> Product Change Notification (PCN)

Product group:	SEMIPACK	Rev.:	0
No.:	PN22-063 SEMIPACK 3 new material of the cap insulator	01 Jun 2022

Subject of change: Introduction of a new material for the cap insulator

SEMIKRON product type: SEMIPACK 3 pressure contact modules

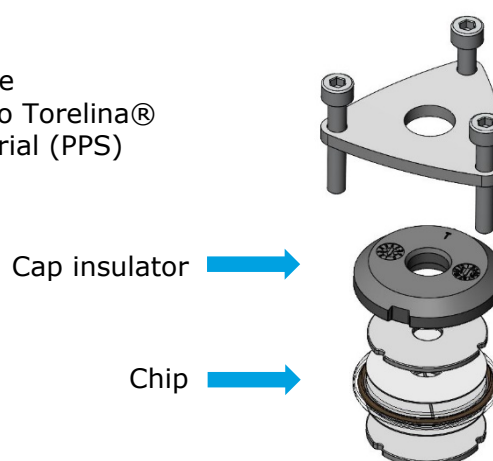
Description of change: Change of the material of the cap insulator from Ryton® to Torelina®
No change of the base material (PPS)

Reason for change: New supplier

Impact of change: No impact on form, fit, function and reliability of the modules
Change of Material Content Datasheet (MCDS)
